**ADDENDUM INFORMATION TO REPORT
 ON CONDITION OF
 AGRICULTURAL BUILDING
 AT
 CROCKWELL FARM, GT BOURTON**

Survey by		
Author	Mark Allen BEng(Hons) CEng MStructE Principal Engineer	August 2021
Reference	AB3522 – BLDG 2 ADDENDUM	Issued 17 TH August 2021

5.0 SKETCHES AND MARKED UP PLANS

ROOF PLAN (STRUCTURE)

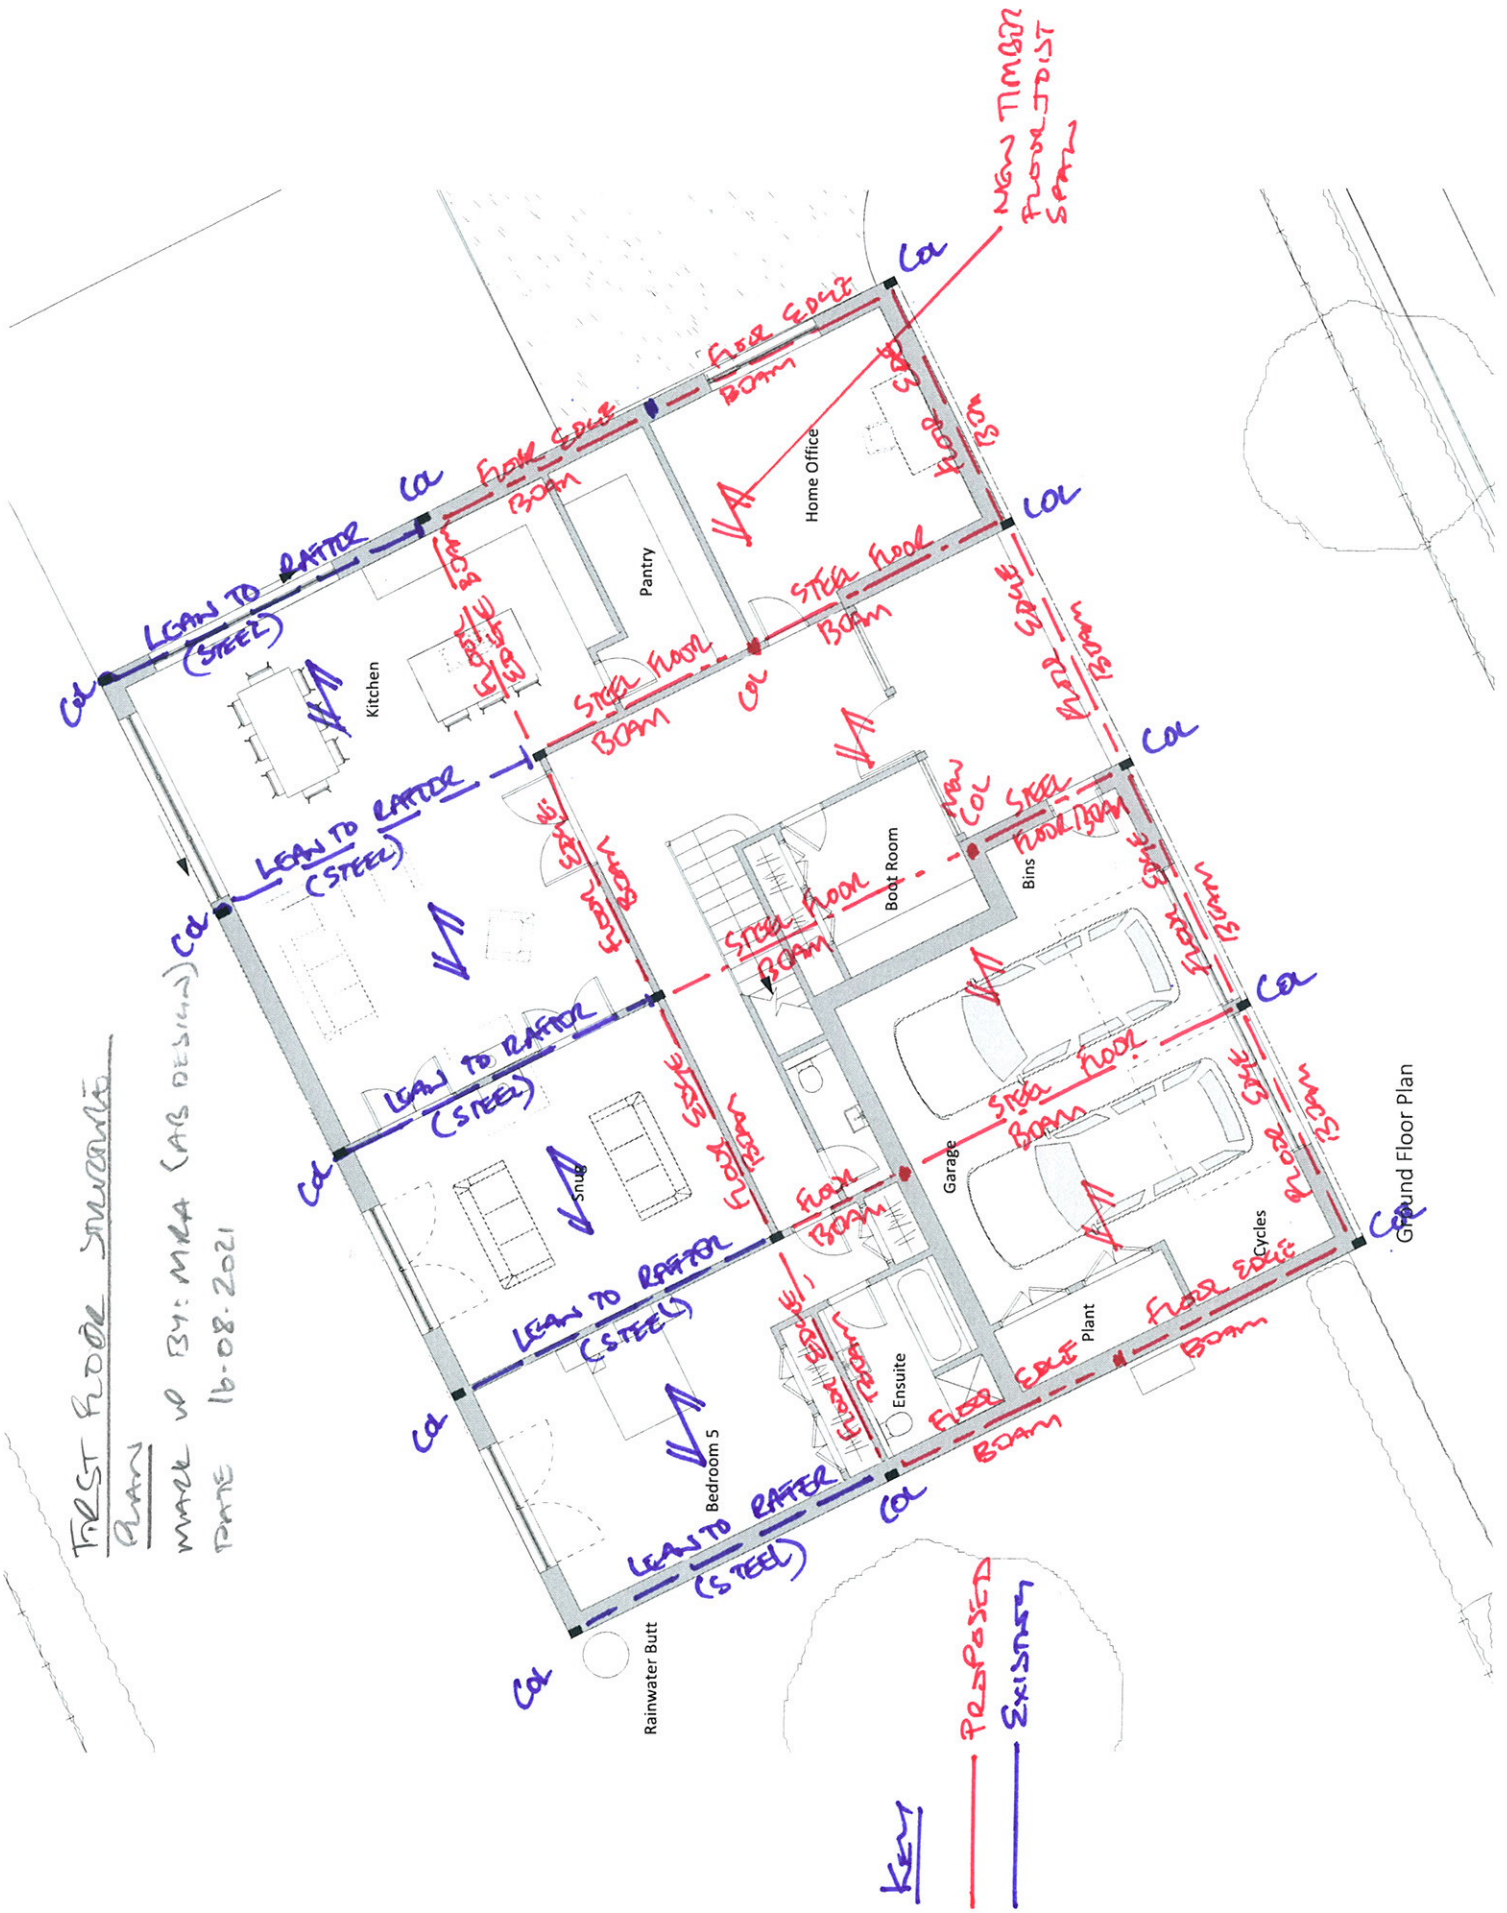
NEW COLUMN TO MATCH OPPOSITE CORNER

FIRST FLOOR STRUCTURE

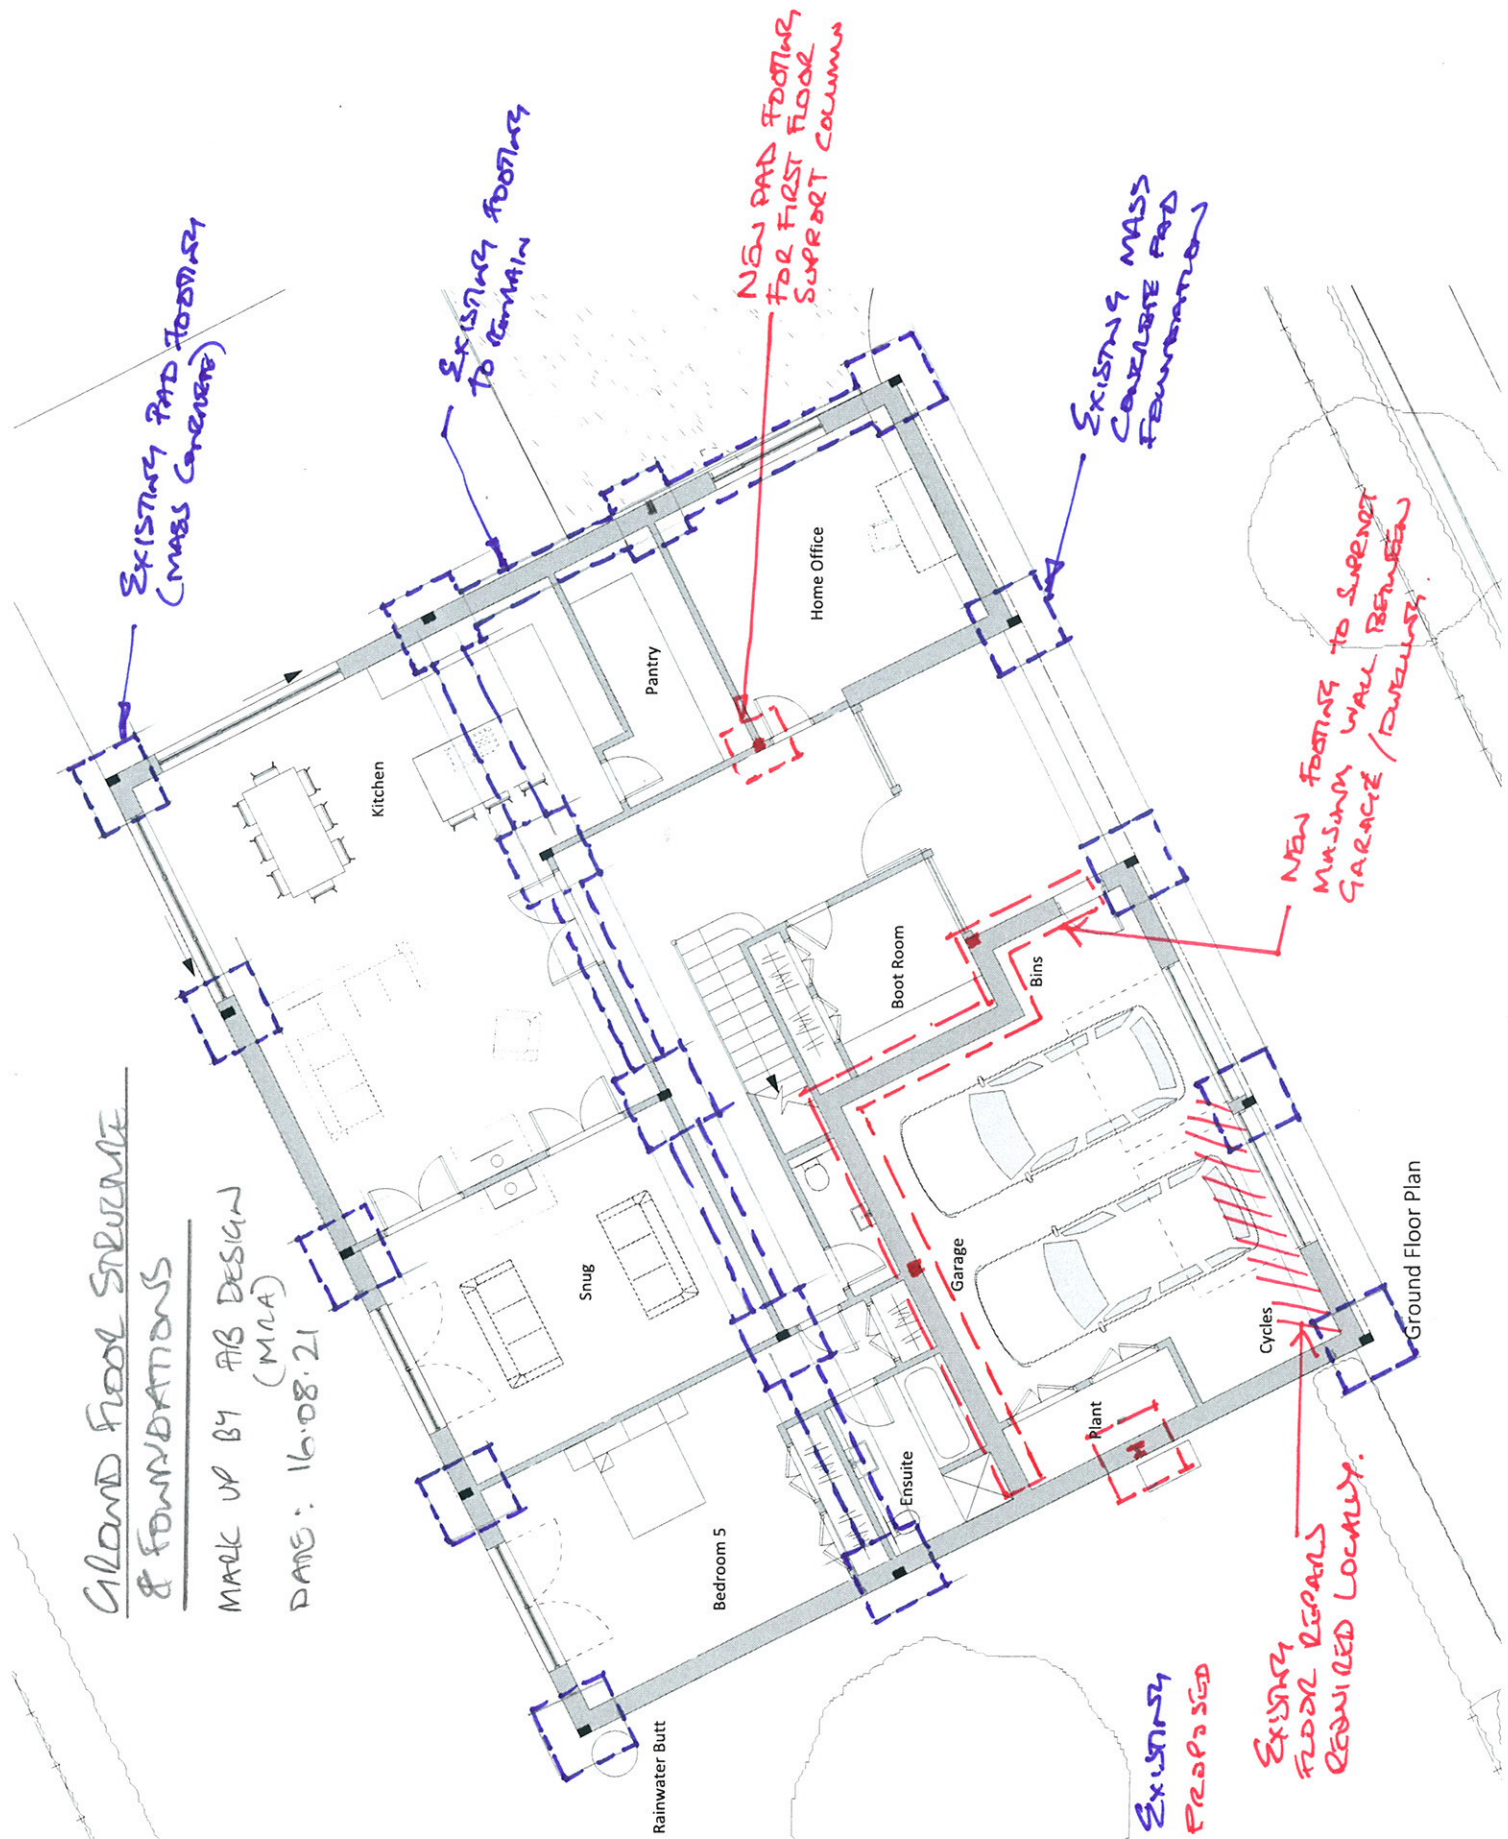
A new first floor has been proposed for the taller part of the building. At present there is not a first-floor structure. Similar to many traditional agricultural barns that are converted. These are usually an addition to the original structure. In this proposal we would suggest that the first floor is constructed with steel edge beams and primary beams spanning between existing columns. This would provide primary support for secondary members such as timber floor joists and floor boarding. Whilst the span of the primary beams is large, and a new intermediate column would be desirable to keep depth of the floor structure to a reasonable overall depth. The new floor structure has two main effects on the original structure. It does place additional load upon the existing portal frames. However, by inherent nature of connecting it to the original portal frames it will provide additional restraint, and thus increasing its strength to be able to carry the additional load and beneficially improves the stiffness of the building without the requirement for additional strengthening of the portal columns. Also, this is the most economical, beneficial and environmentally conscious way of adding a first floor, by utilising what structure exists.

GROUND FLOOR STRUCTURE & FOUNDATIONS

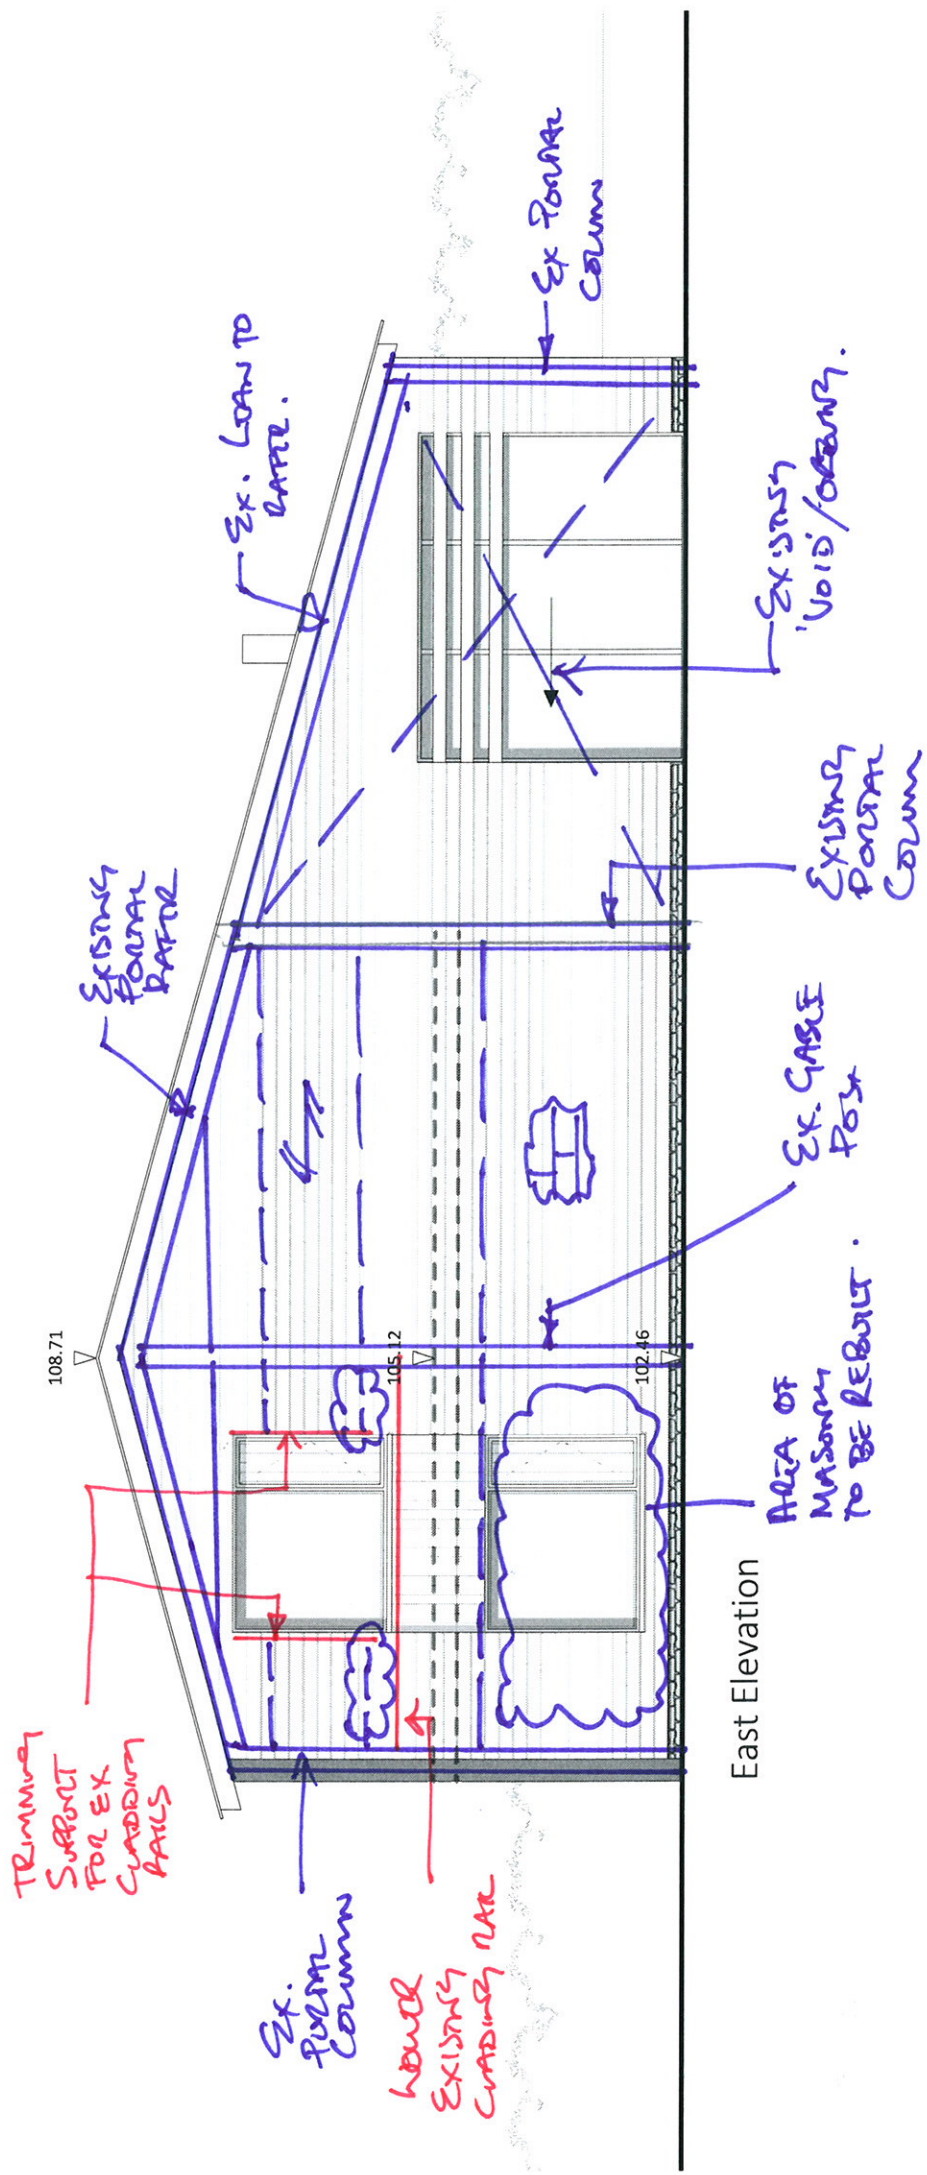
EXISTING FLOOR REPAIRS REQUIRED LOCALLY.

NEW FOOTINGS TO SUPPORT MURKIN WALL BETWEEN GARAGE/DWELLING.

NEW PAD FOOTINGS FOR FIRST FLOOR SUPPORT COLUMN

East Elevation

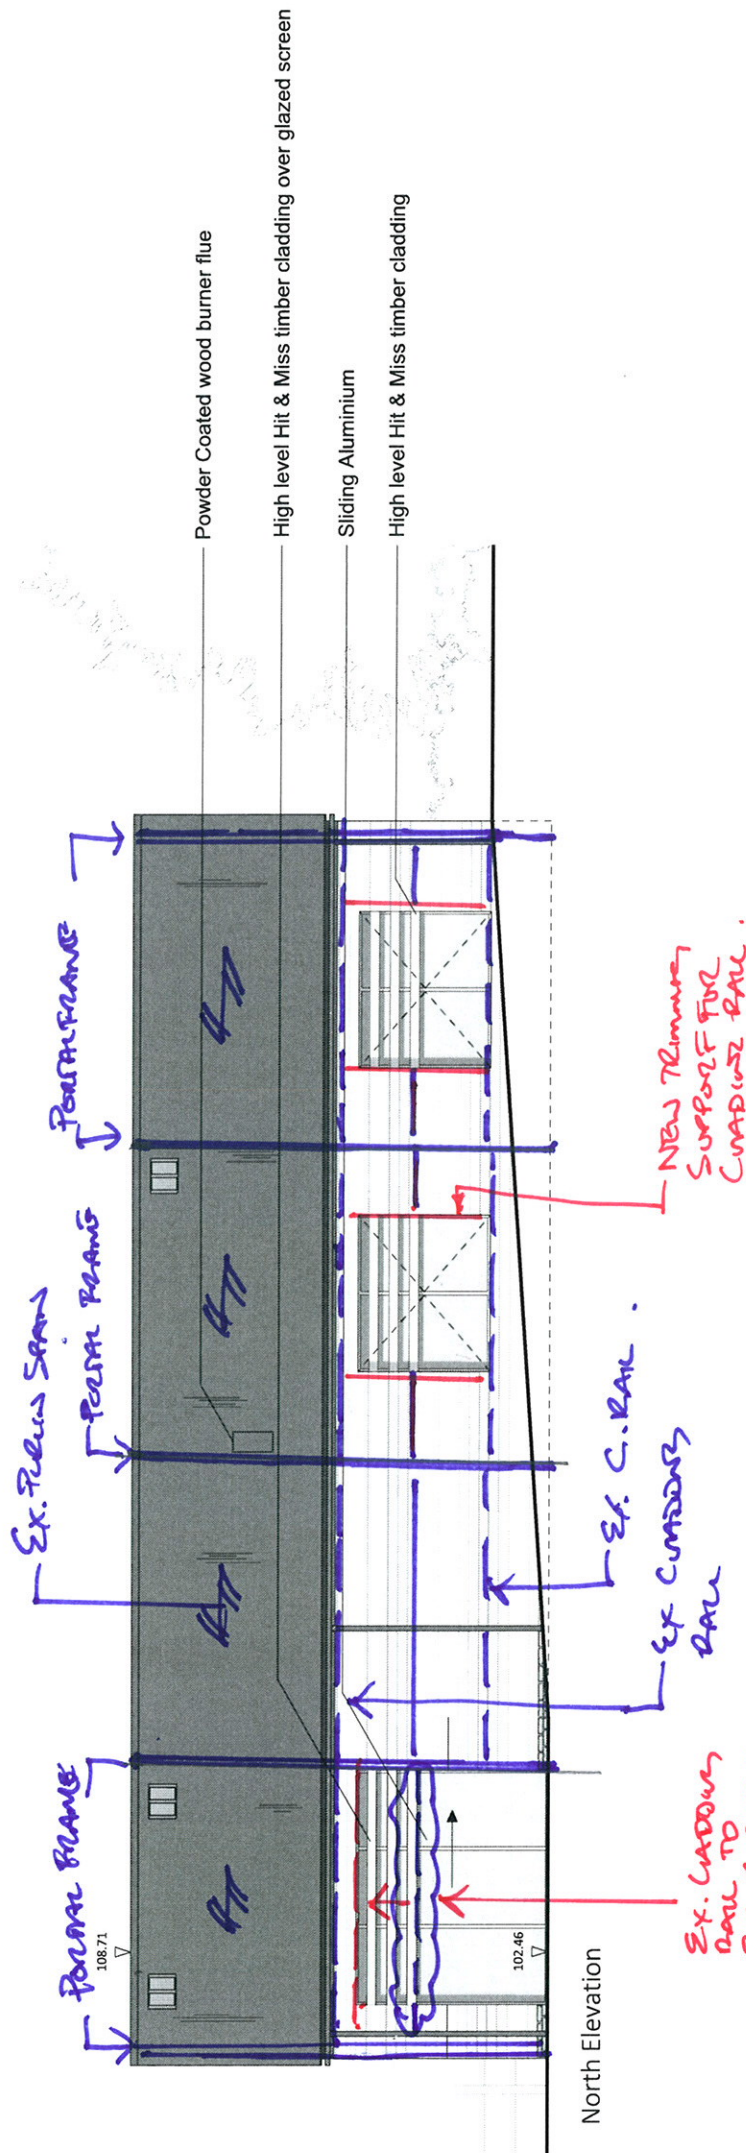
TRIMMING
SUPPORT
FOR EX
CURBING
PAIS

LOWER
EXISTING
CURBING PAIS

AREA OF
MASONRY
TO BE REBUILT.
